STAFF REPORT
COMMUNITY DEVELOPMENT DEPARTMENT

HEARING DATE: January 5, 2023
 DATE: *Continued from: December 1, 2022*

SUBJECT: H-2022-0027
 Sagarra – PUD, PP
 (aka Linder Village)

LANDSCAPE PLAN - OVERALL:

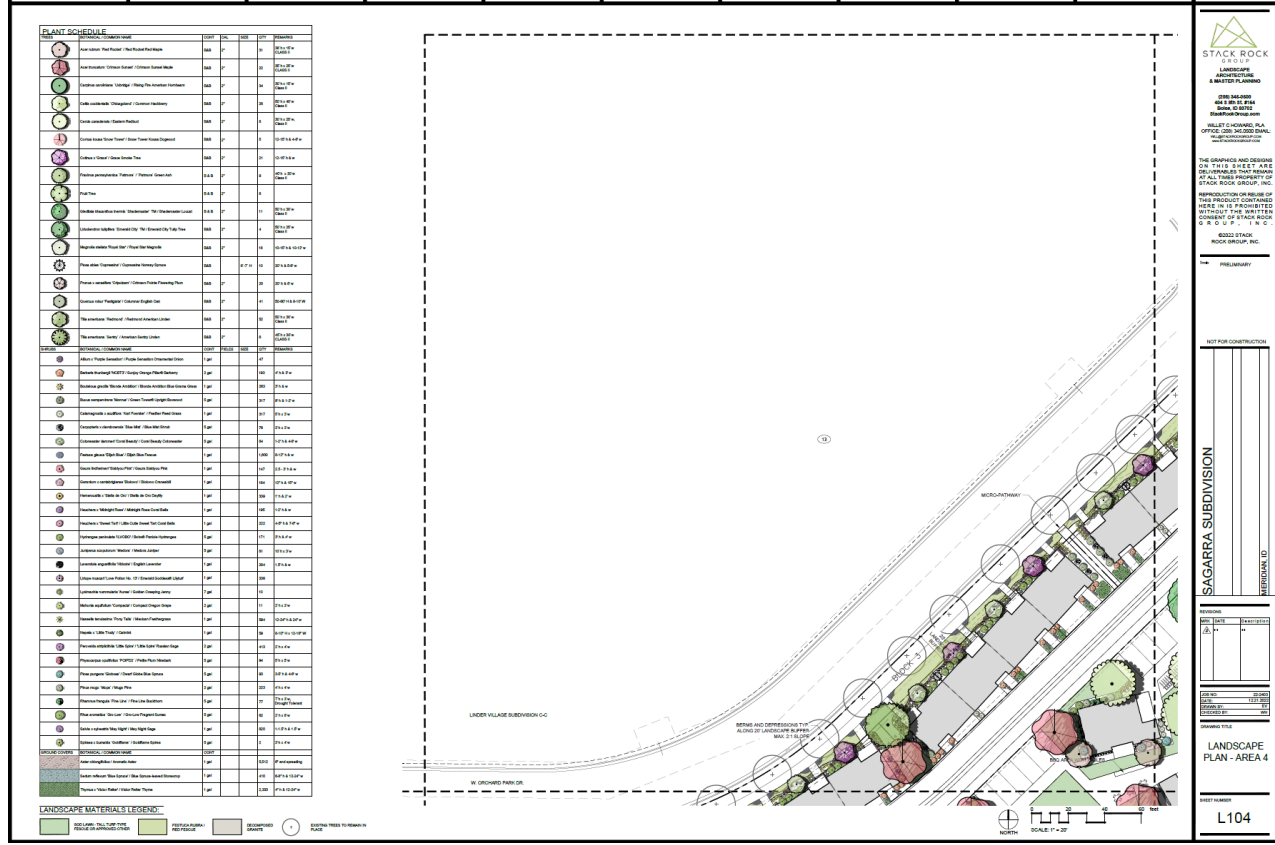
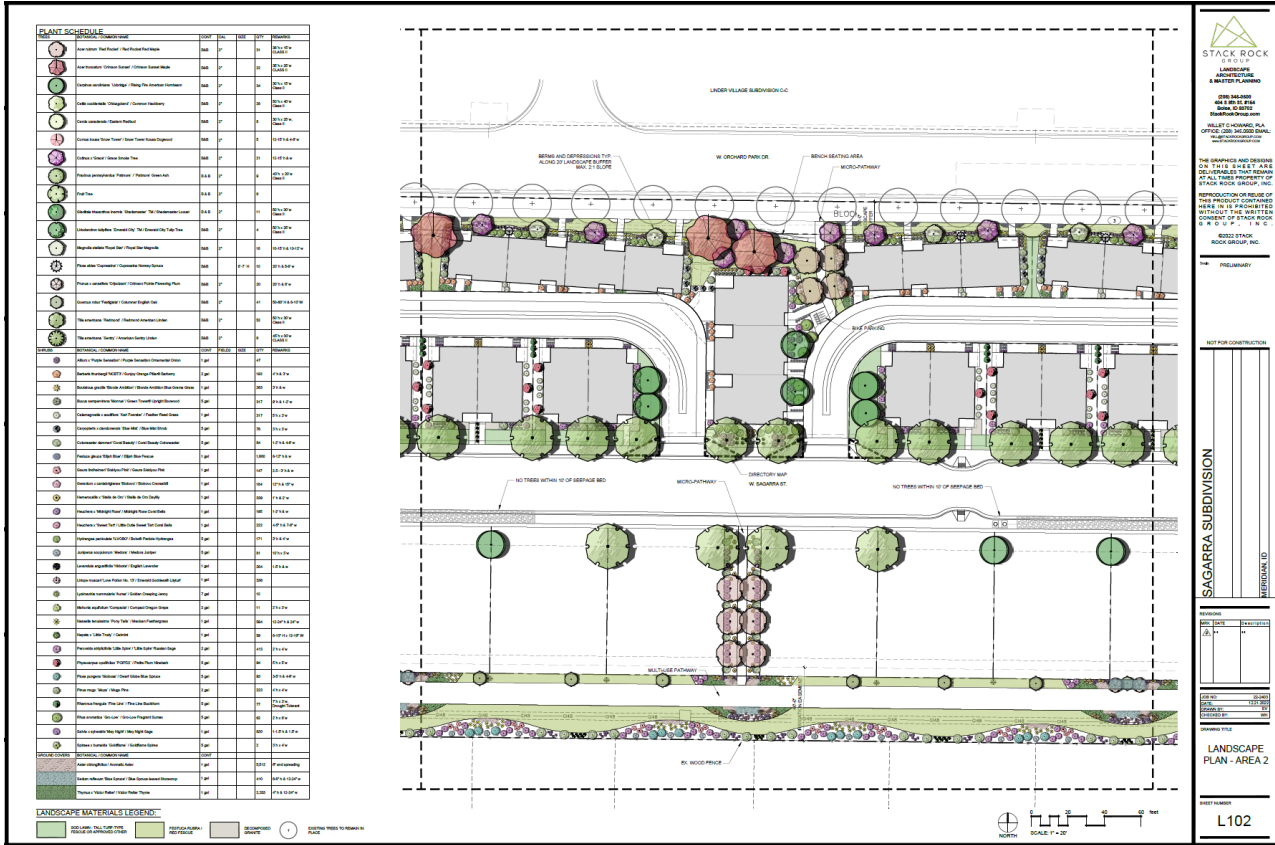
Landscaping is required in common open space areas in accord with the updated standards listed in UDC 11-3G-5B.3, which requires a minimum of one deciduous shade tree for every 5,000 square feet of area with a variety of trees, shrubs, lawn or other vegetative groundcover. **The Landscape Requirements table on the landscape plan and the Site Amenity Plan should be updated to reflect compliance with the updated standard.**

road/multi-use pathway is proposed is encompassed by an irrigation easement that prohibits trees within the easement. **Prior to the City Council hearing, an Alternative Compliance application should be submitted to relocate the trees required in this area to along micro-paths within the development, as proposed; shrubs and other plantings should be provided within this area if allowed by the easement holder in accord with UDC 11-3B-12C.2.**

- c. Update the Landscape Requirements table to reflect compliance with the updated common open space standards in 11-3G-5B.3, which requires a minimum of one deciduous shade tree for every 5,000 square feet of area with a variety of trees, shrubs, lawn or other vegetative groundcover; shrubs and other plantings shall be depicted on the plan as required.

- c. Depict landscaping along all the foundation of all street facing elevations in accord with the standards listed in UDC [11-4-3-27E](#).
 - d. Depict shrubs and other plantings adjacent to the pathway along the south and east boundaries of the site in accord with UDC [11-3B-12C](#) as allowed by the Irrigation District within their easement.

C. Common Open Space Exhibit (dated: ~~3/22/2022~~ 12/21/2022) – REVISED

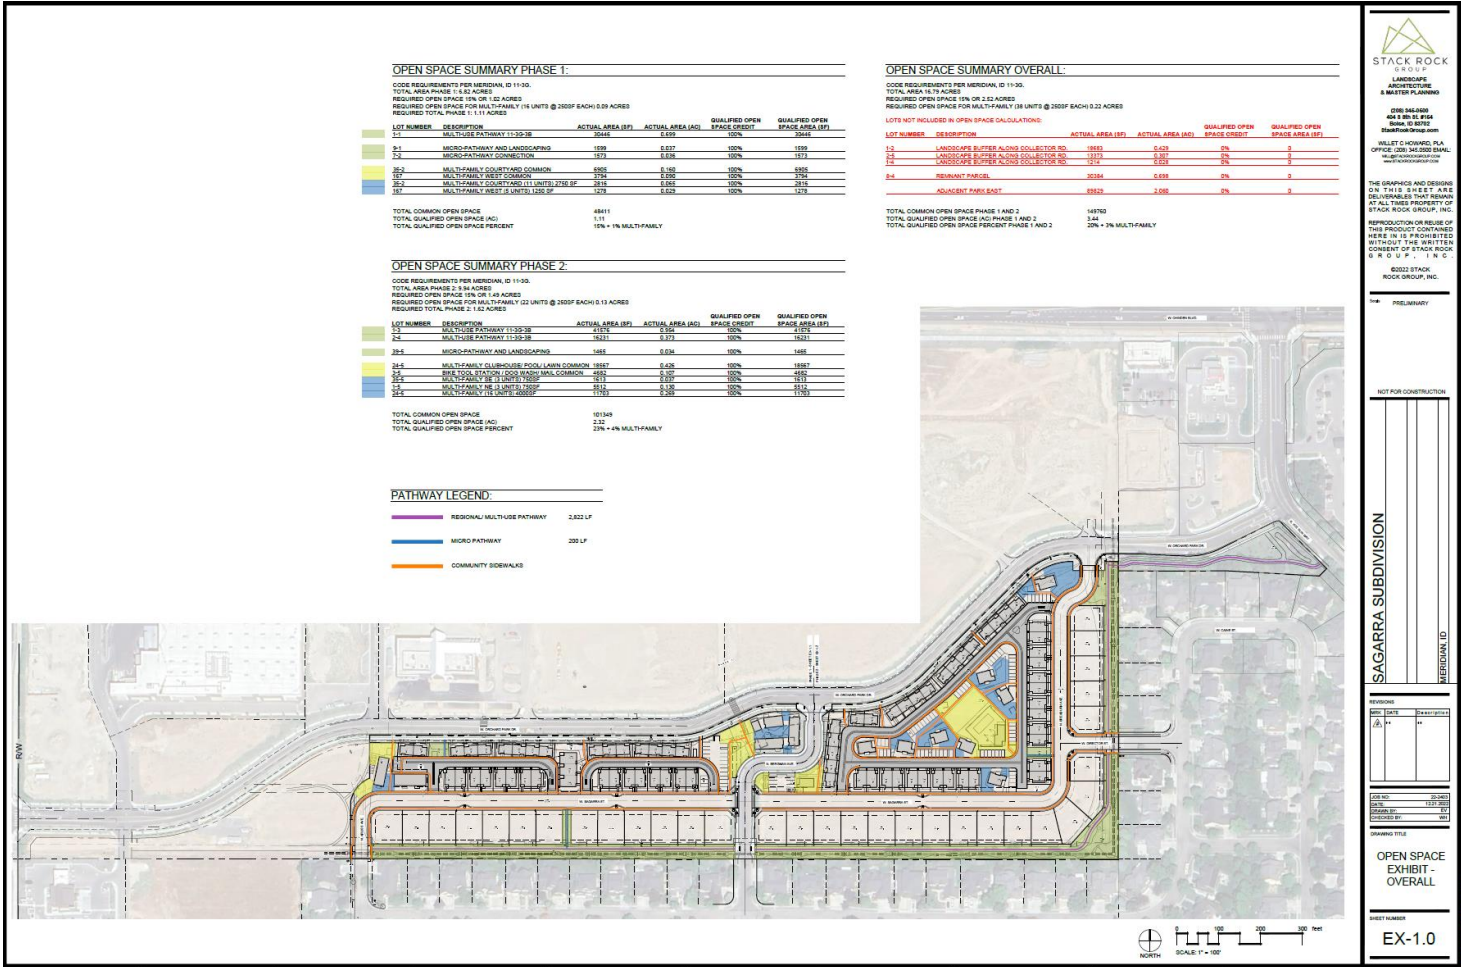
The common open space exhibit is *not* approved as submitted and should be revised to comply with the common open space standards prior to the City Council hearing; or an application for alternative compliance to these standards may be submitted if the proposed design includes innovative design features based on “new urbanism”, “neotraditional design”, or other architectural and/or site designs that promote walkable and mixed use neighborhoods (see UDC [11-5B-5](#) for more information).

Common open space shall be not less than four hundred (400) square feet in area, and shall have a minimum length and width dimension of twenty feet (20'). *The open space exhibit should be revised*

- Submit a revised qualified open space exhibit that demonstrates compliance with the minimum open space standards in UDC [11-3G-3B](#) and [11-4-3-27C](#). Overall, a minimum of 2.74-acres of qualified open space is required to be provided. Areas that don't meet the minimum qualifications should be removed from the plan. The scale bar depicted on the plan should also be corrected. An application for alternative compliance to these standards may be submitted if the proposed design includes innovative design features based on "new urbanism", "neotraditional design", or other architectural and/or site designs that promote walkable and mixed-use neighborhoods (see UDC 11-5B-5 for more information). *A revised common open space exhibit was submitted, included in Section VII.C, that depicts a total of 3.43 acres of qualified open space, which exceeds the minimum standards by 0.69-acre.*

F. Parking Diagram – REVISED

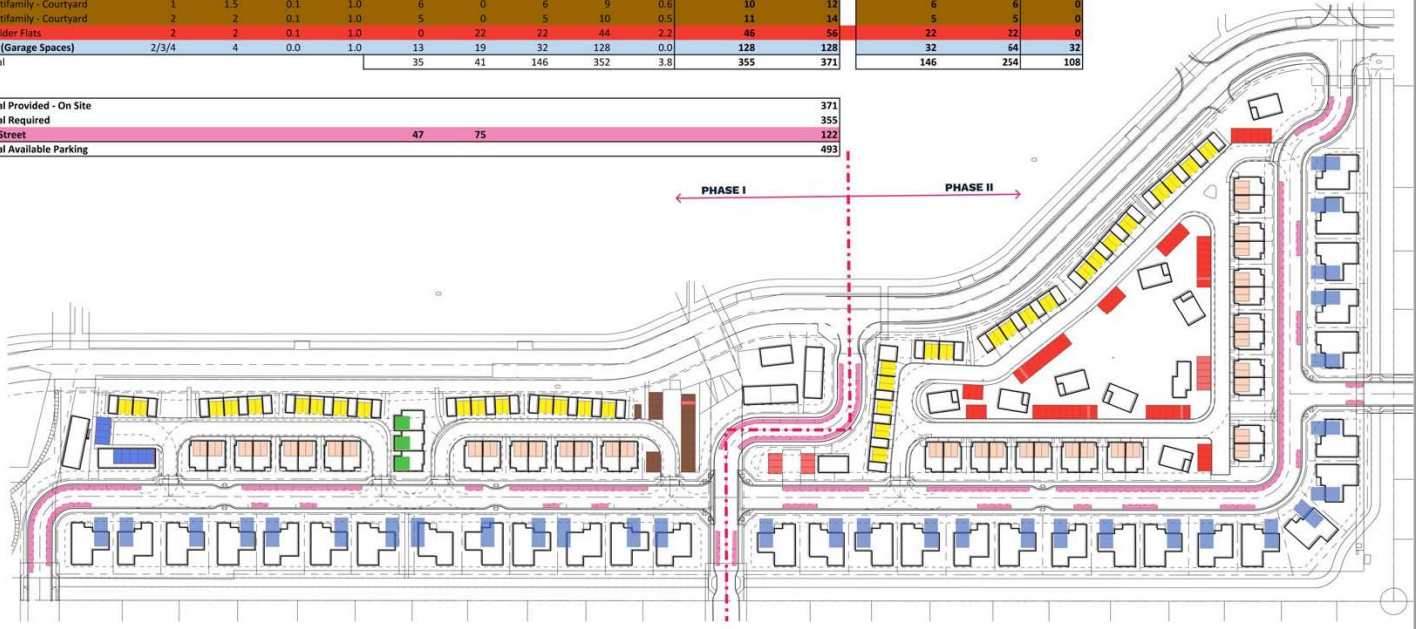
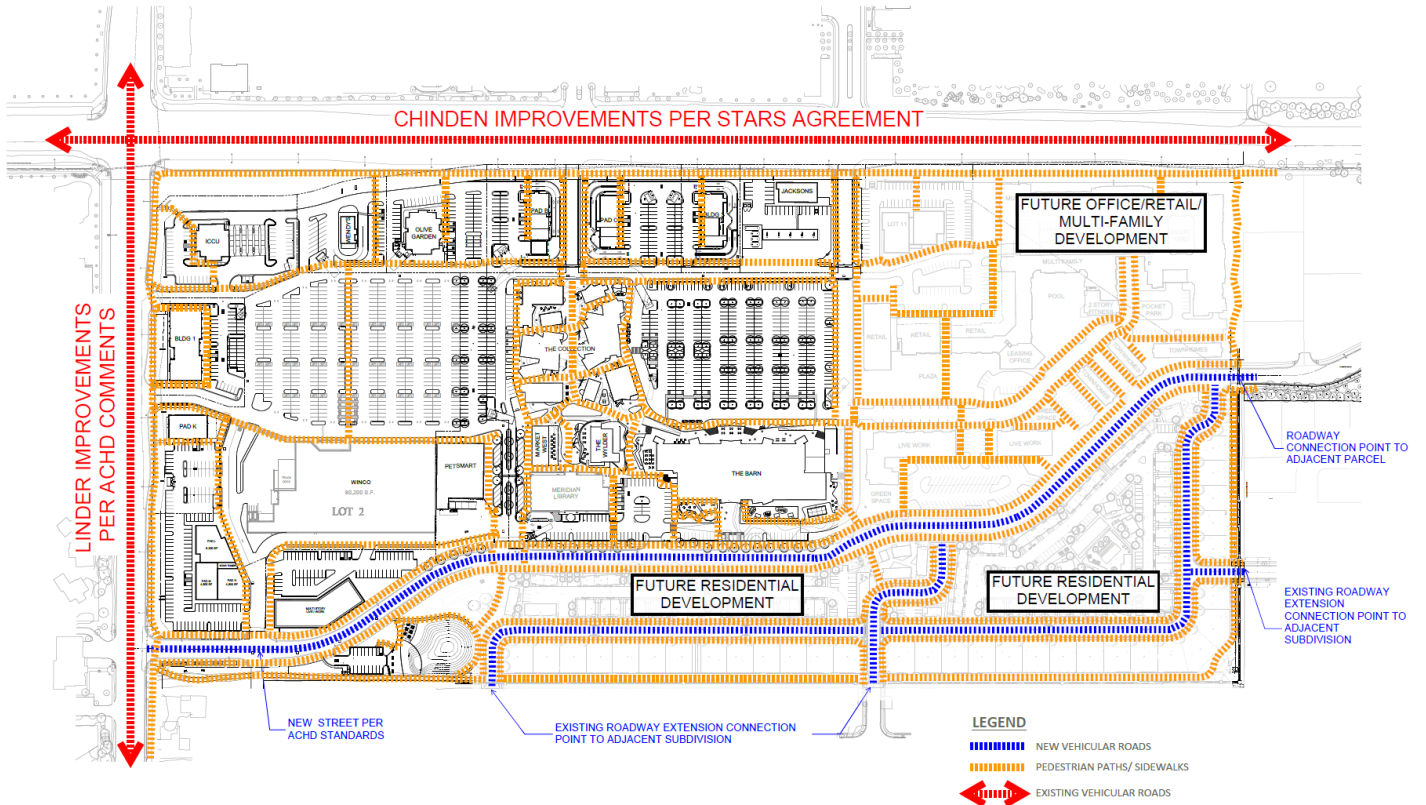
~~Staff is unable to determine compliance with the minimum standards until a revised parking exhibit is submitted. The proposed off-street parking complies with and exceeds the minimum standards by 16 spaces; an additional 122 on-street parking spaces are also available (see Section VII.F).~~

- Submit a revised off-street parking exhibit that demonstrates compliance with the minimum standards listed in UDC [Table 11-3C-6](#). *See updated parking calculations in Section VII.F. The proposed parking complies with and exceeds the minimum standards by 16 spaces; an additional 122 on-street parking spaces are also available.*
